South Texas Project  
Units 3 and 4  
Docket Nos. 52-012 and 52-013  
Revised Response to Request for Additional Information

RAI 09.01.02-9

Attachment: RAI 09.01.02-9 Response Revision 1

Summary: Provide additional information about the seismic loading for the nonlinear time history analysis of the spent fuel racks.

Figure 1 Comparison of Input vs. Calculated Response Spectra, Horizontal (X)

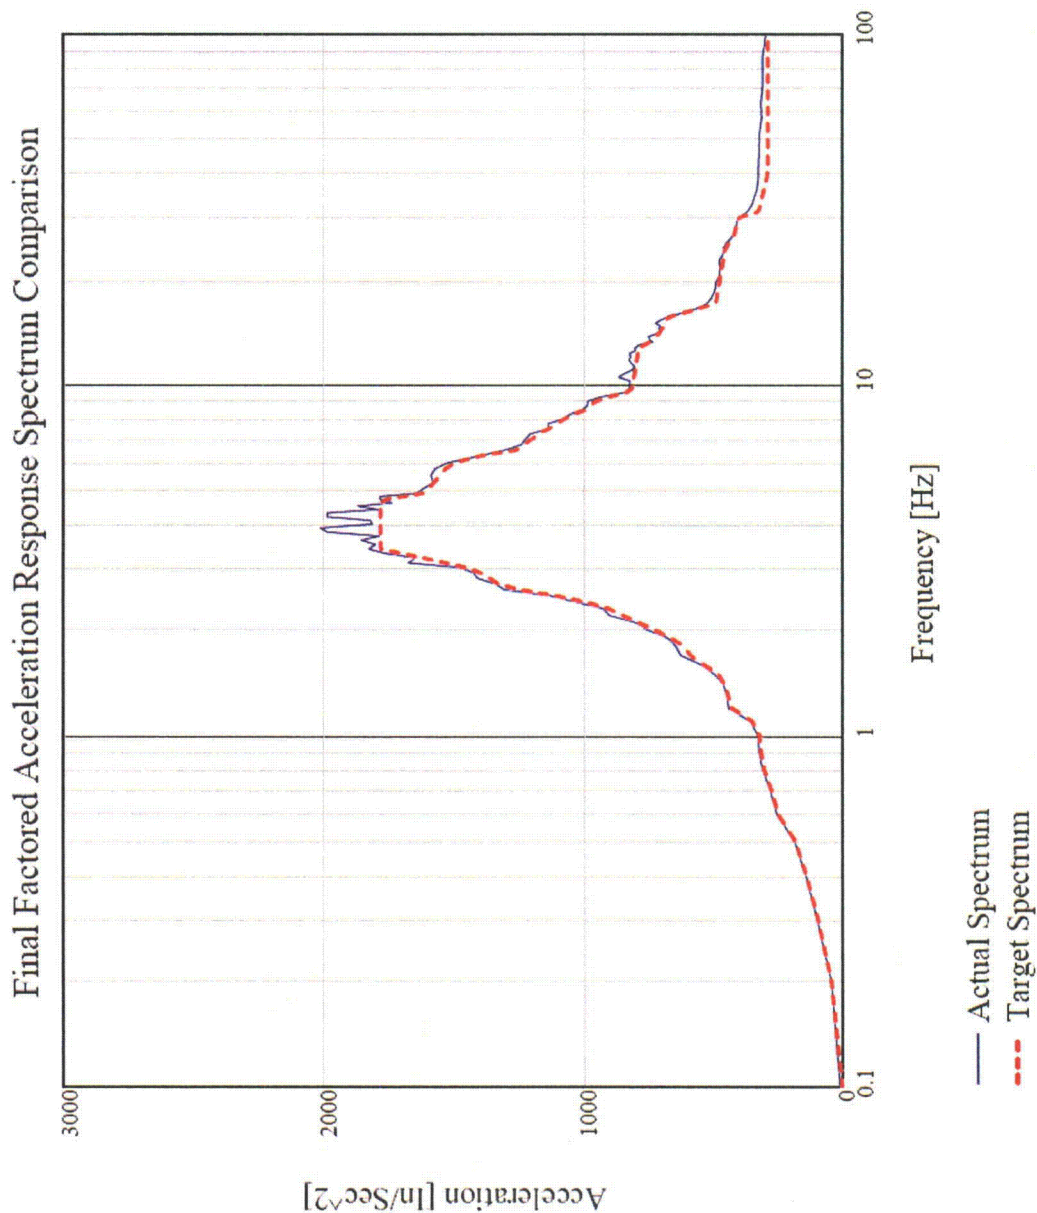
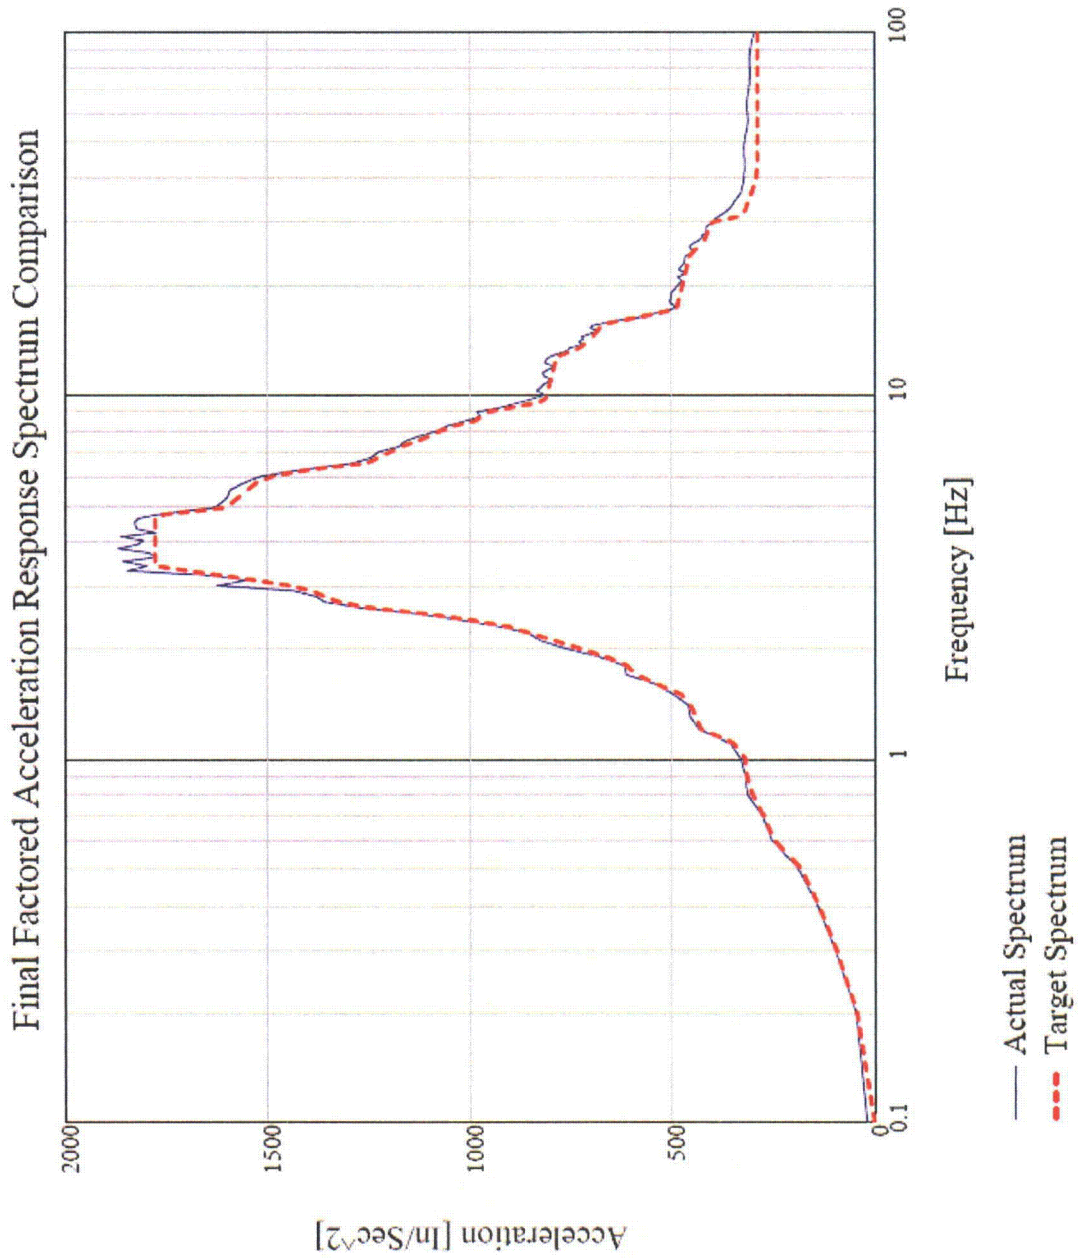
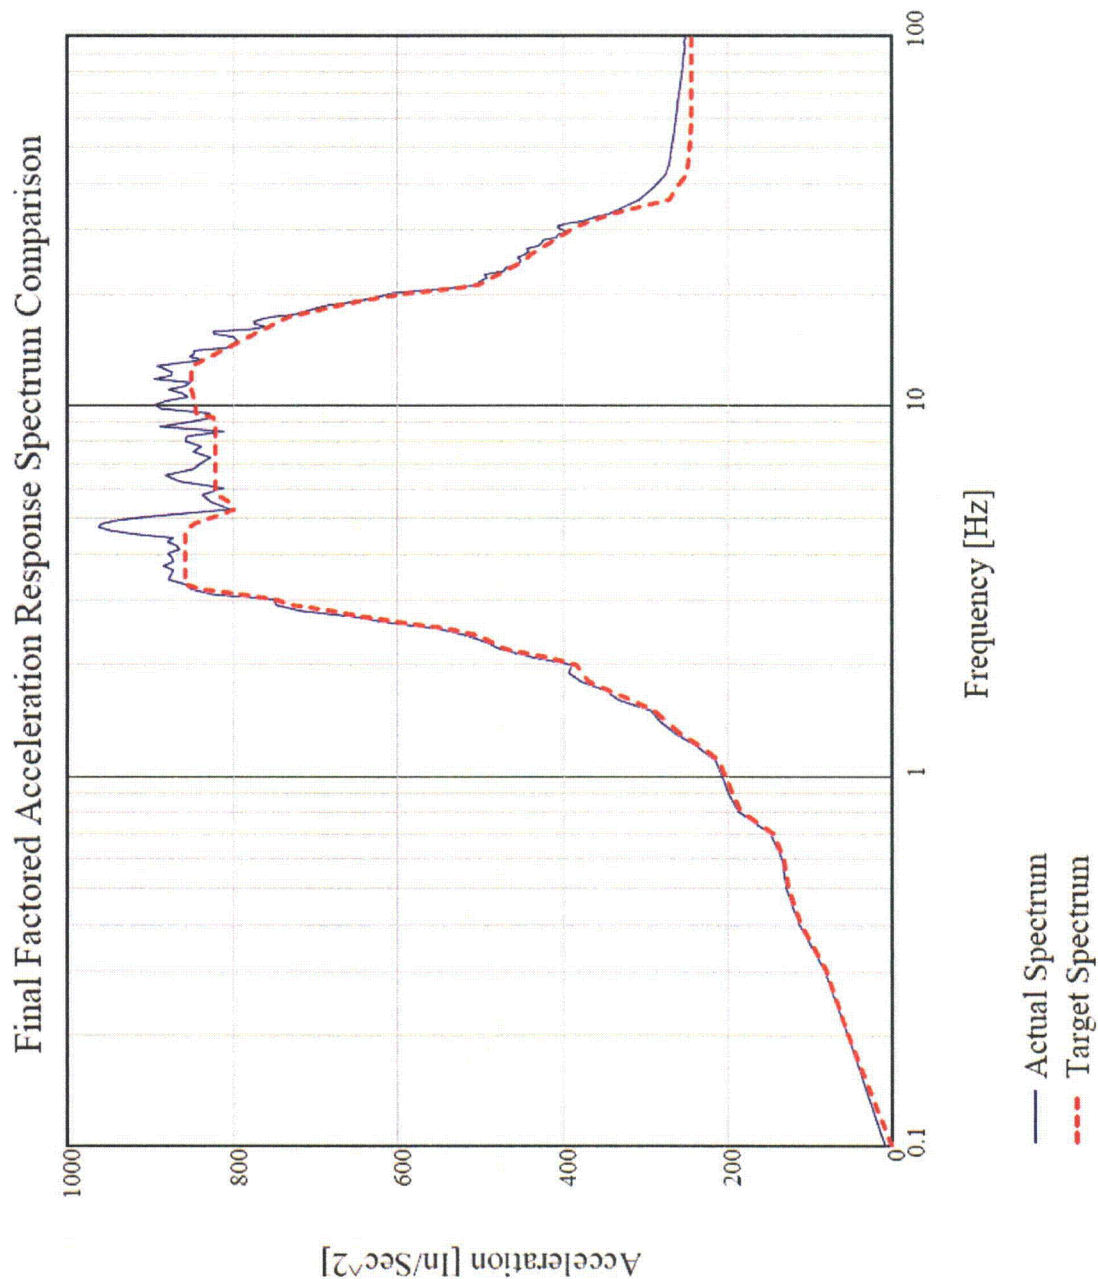
- a. Confirm that the 3 synthetic time histories have been checked against each other to ensure statistical independence. Compare the calculated correlation coefficients to the acceptance criterion of  $\leq 0.16$ . Include this information in the spent fuel racks technical report.
- b. Provide figures comparing the 5% damped spectra (2 horizontal, vertical) generated from the synthetic time histories to the 5% damped target spectra (horizontal, vertical) at node 100. Identify the criteria used to verify the adequacy of the match. Include this information in the spent fuel racks technical report.

- b. The following figures show the comparison of the 4% damped spectra (2 horizontal, vertical) generated from the synthetic time histories to the 4% damped target spectra (horizontal, vertical) at node 100. Per the requirements of NUREG-0800, Standard Review Plan 3.7.1, the SRP Acceptance Criteria on page 10 states that “Each calculated spectrum of the artificial time history is considered to envelop the design response spectrum when no more than five points fall below, and no more than 10 percent below, the design response spectrum.” Synthetic time histories were created for 4% damping at Node 100, per the requirements of Reg Guide 1.61, “Damping Values For Seismic Design Of Nuclear Power Plants,” as required for welded steel or bolted steel structural material with friction connections (RG 1.61, Table 1, “SSE Damping Values”), not the 5% as requested above.

The following table shows compliance to the NUREG-0800, Standard Review Plan Section 3.7.1 for Response Spectra Comparison (the number of points below the target is less than or equal to 5, and the maximum percent under the target is less than 10%):

Figures 1, 2, and 3 show that the synthetic generated time histories envelope the target response spectra using 4% damping at Node 100 for all three directions. This information will be included in the spent fuel racks Technical Report.

**Figure 4 Actual Raw and Average PSD vs. Target – Horizontal (X)**

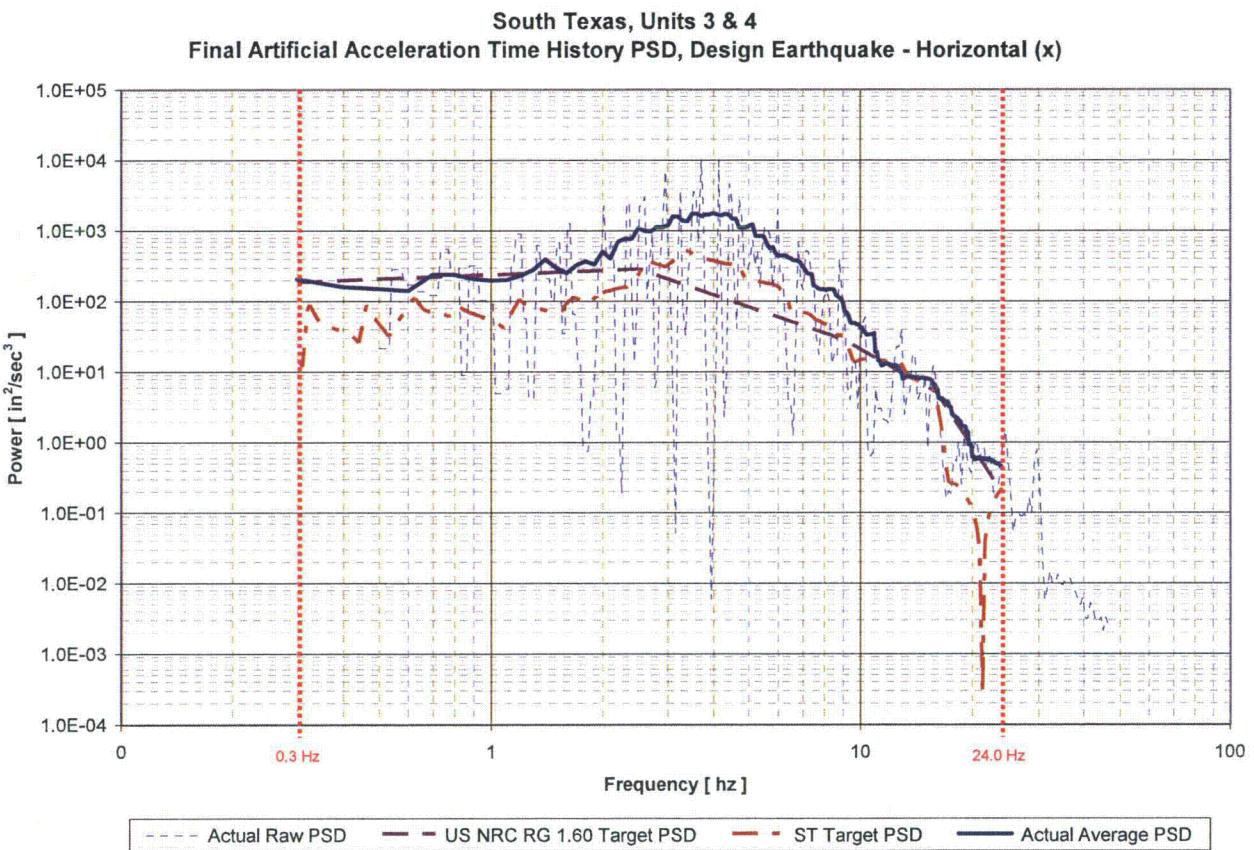
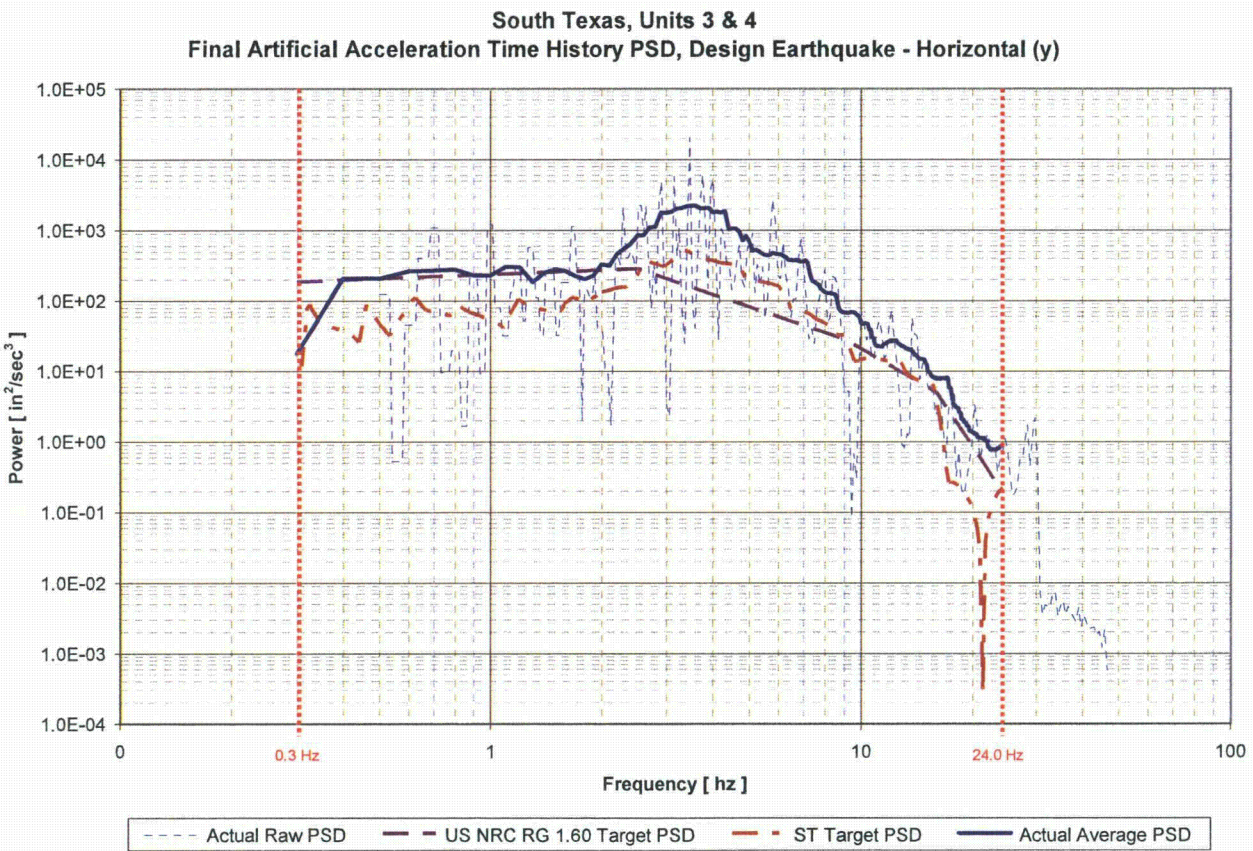
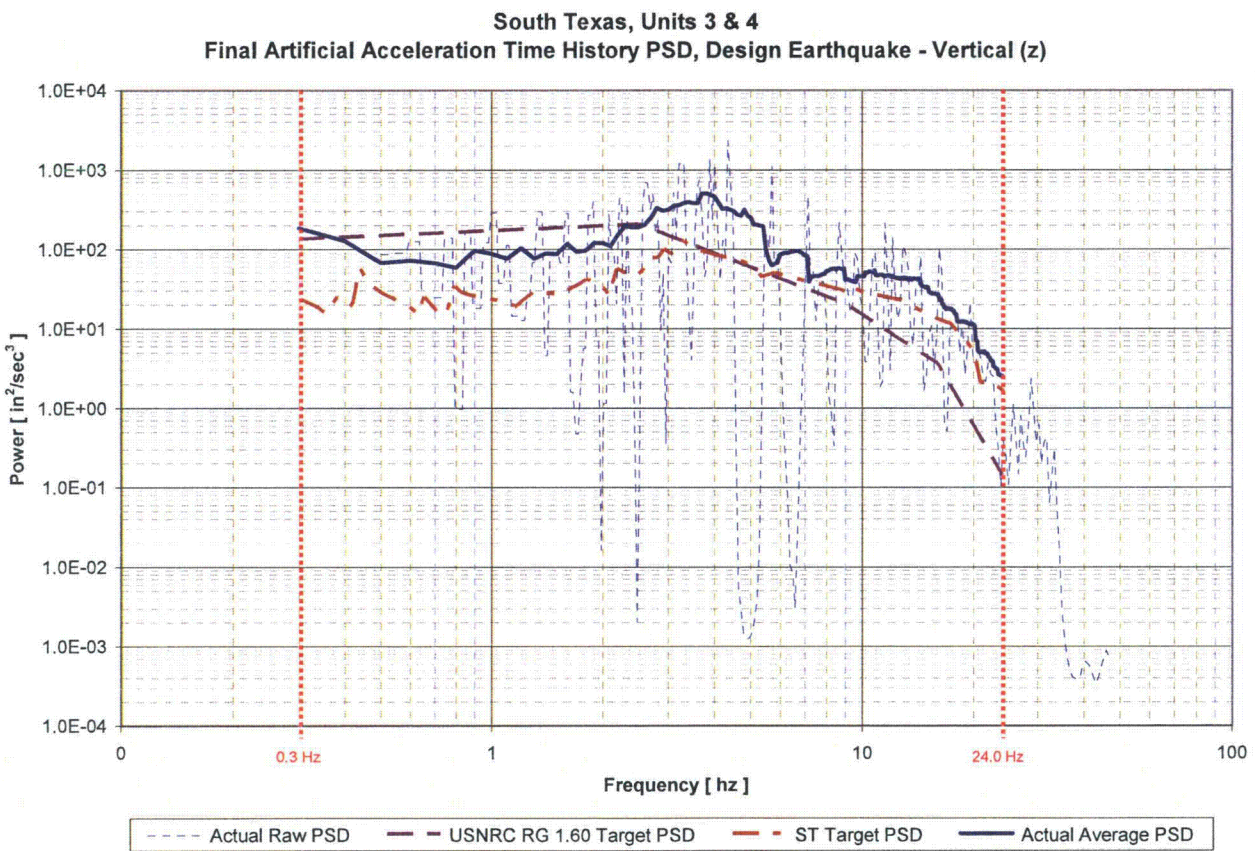
- c. Describe how target PSDs were developed for the Node 100 target spectra, and provide figures comparing the PSDs for the synthetic time histories to the PSDs for the target spectra. Identify the criteria used to verify the adequacy of the PSDs for the synthetic time histories.

Figures 4, 5, and 6 are plots of the 80% NRC target PSD function, the actual raw PSD, the actual average PSD, and the site-specific target PSD function for each case.

It can be seen that the actual average PSD curves are above the STP-specific target PSD curves with exceptions as follows:

- X direction, around 15Hz, the actual average is approximately equal to the target.
- Y direction, around 0.32 Hz, the actual average is below the target.

The PSD check that is required by SRP Section 3.7.1 is for synthetic motion generated at the ground level. Because the STP 3&4 synthetic motion is at a higher elevation within containment, the PSD check has been conservatively applied at the higher elevation. There are two small frequency ranges (between 0.3-0.4 Hz in the horizontal "Y" direction and

between 10-20 Hz in the horizontal "X" direction) where the actual PSD is below the site specific target PSD. The actual PSD is very close to the target PSD within these frequency ranges, and because the input response spectra is at an elevation above ground level, the artificial time history data is deemed acceptable.
